PROJECT
200 THE BROADWAY, YMCA
LONDON, SW19 1RY

TITLE
Roof Plan

PROJECT	ORIGINATOR	ZONE	LEVEL	TYPE	ROLE	NUMBER
YMCA	DLA	09	DR	A		249

Proposed Roof Plan

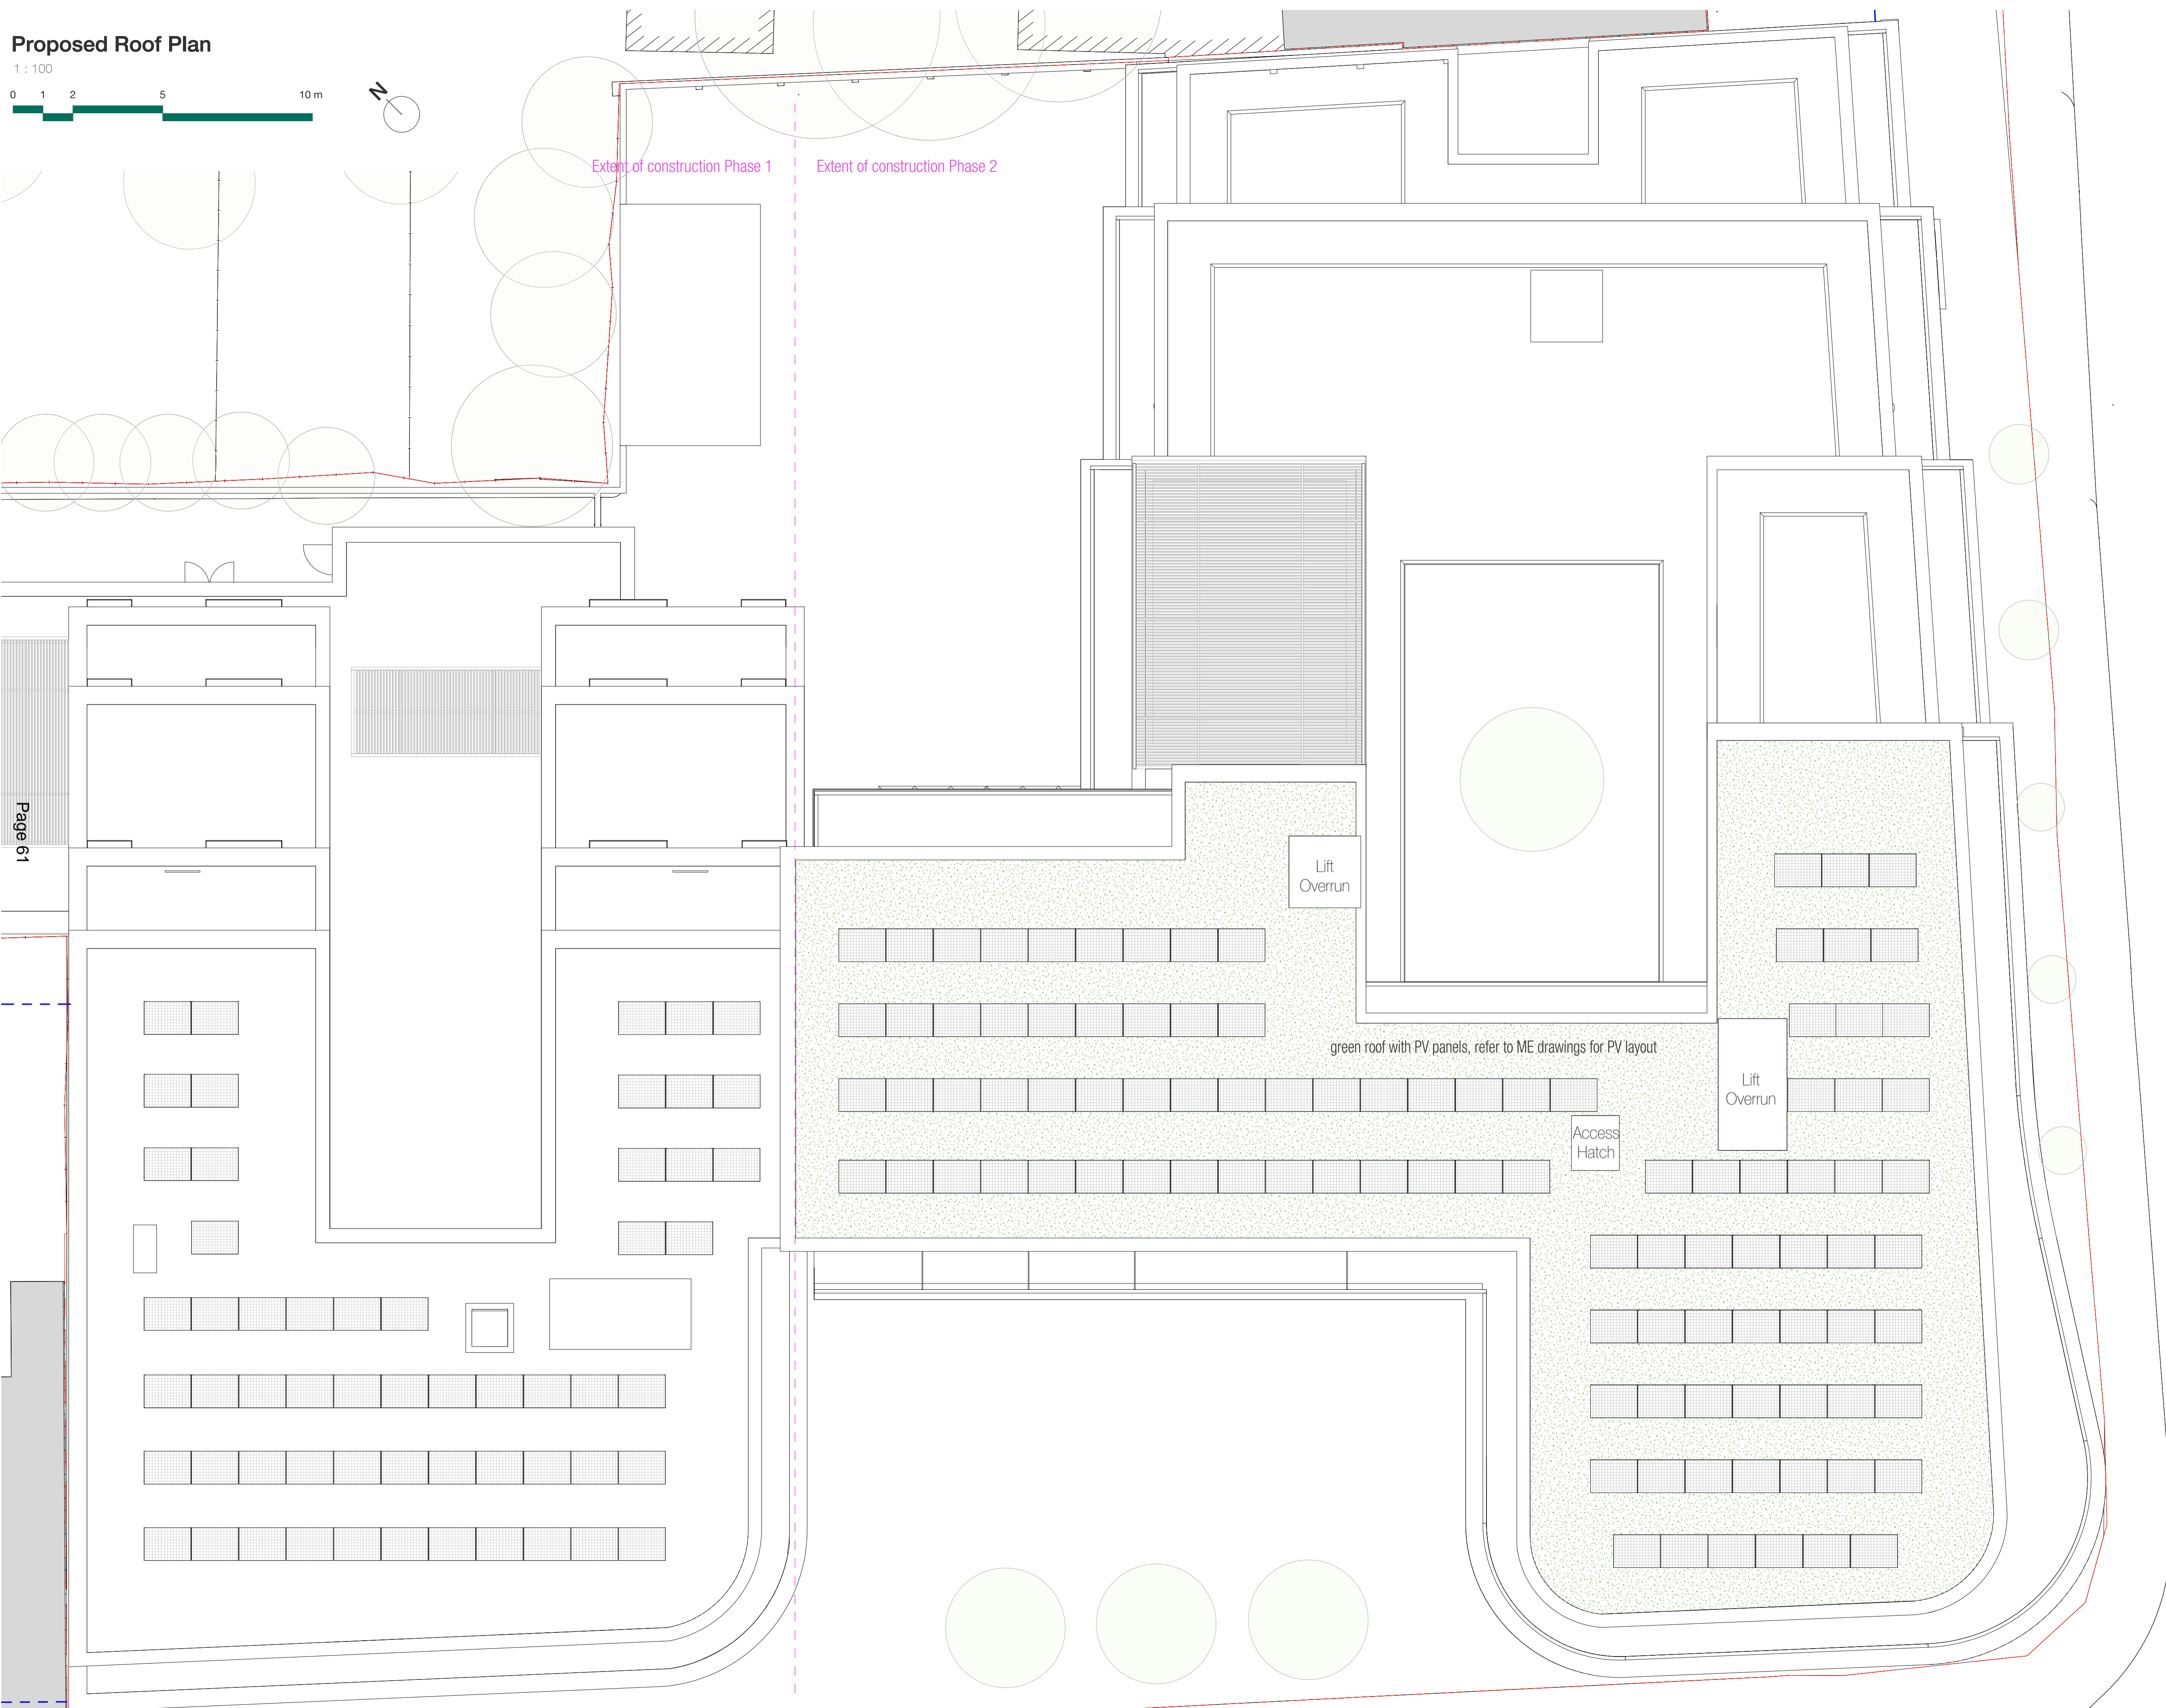
- Reduction in bedroom size in the 1b1p units.
- Addition of 750mm zone around beds in 1b2p central block units.
- Boundary treatment to ground floor duplexes on Trinity Road reduced from 1.5m height to 1.2m.
- Ground floor duplex gardens/bins store reconfiguration.
- Additional side door from servicing corridor to central commercial unit.
- Amendments to the enlarged cycle parking spaces to provide a secured and lockable store.
- Short stay cycle parking relocated from Trinity Road to central piazza.
- Provision of clear link from service yard to residential concierge lobby.
- Windows in YMCA amended to show perforated panels to avoid overlooking.
- Screen aligned with vertical mullions in central block façade facing The Broadway.
